building section

A-9

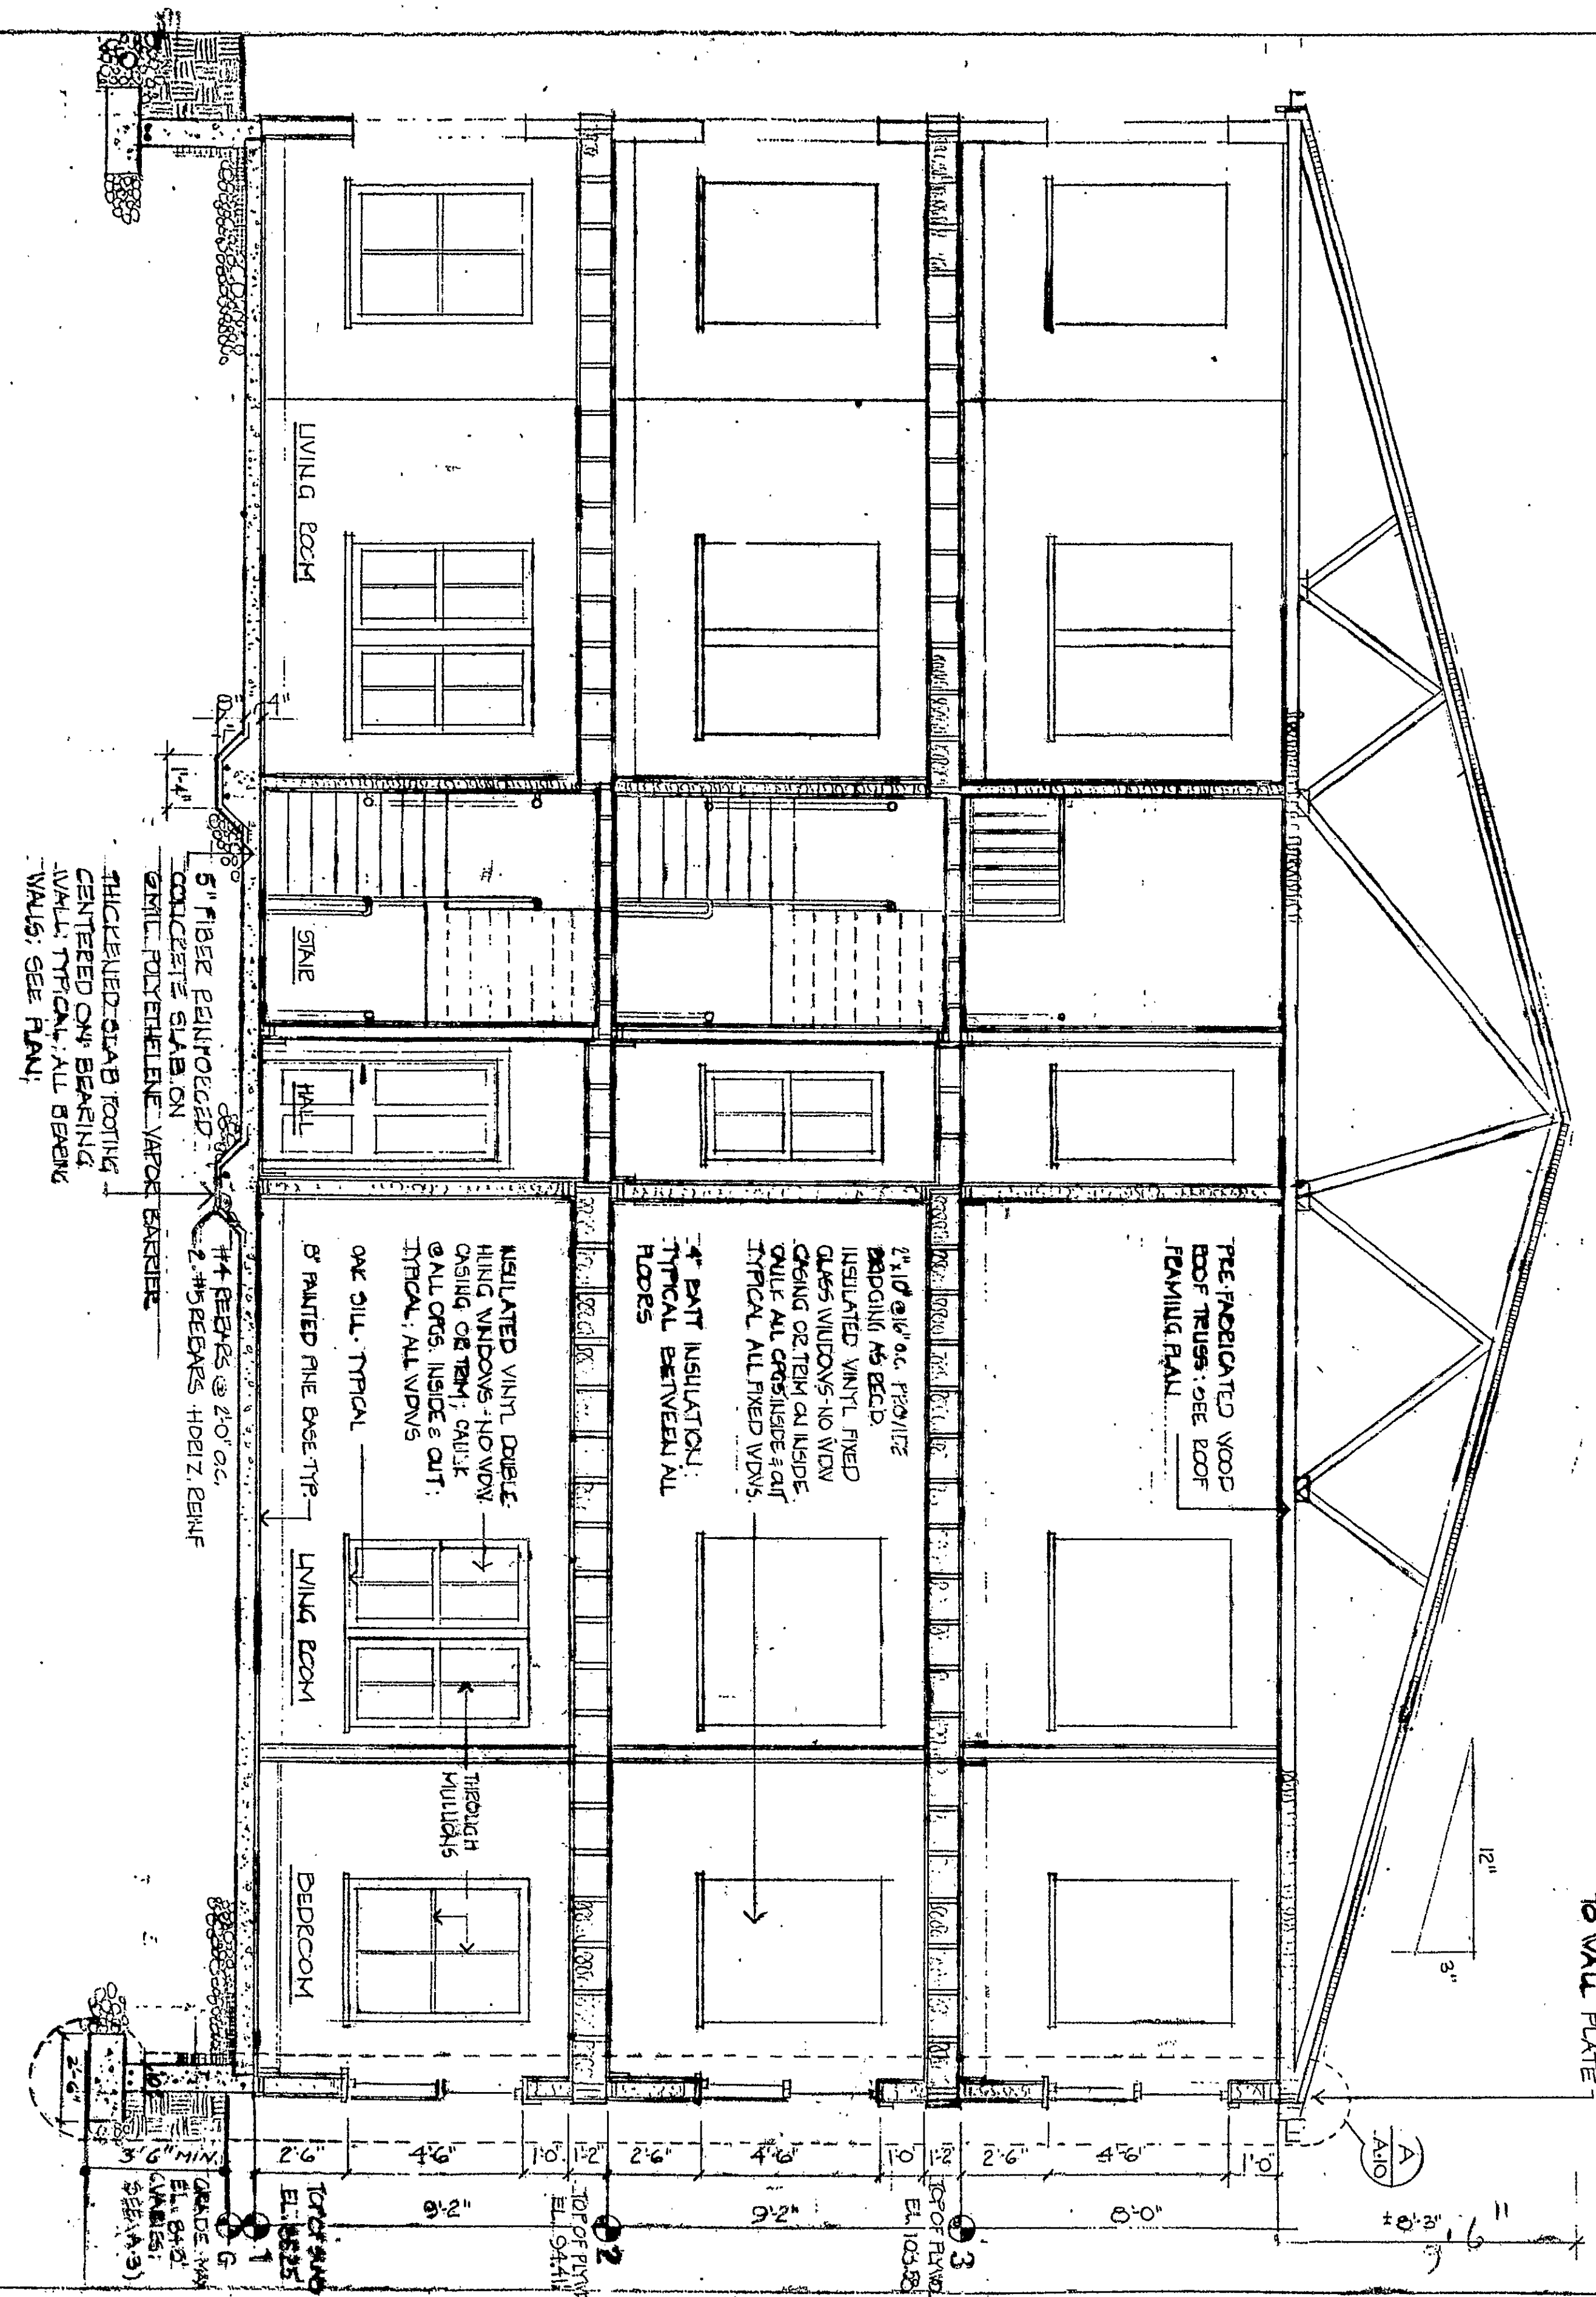
- REVISED 4/19/88
1. CHECK SOIL IF REQUIRED
 2. KEVED SLAB INTO WALL
 3. CHANGE MIN. DEPTH TO 3'6"
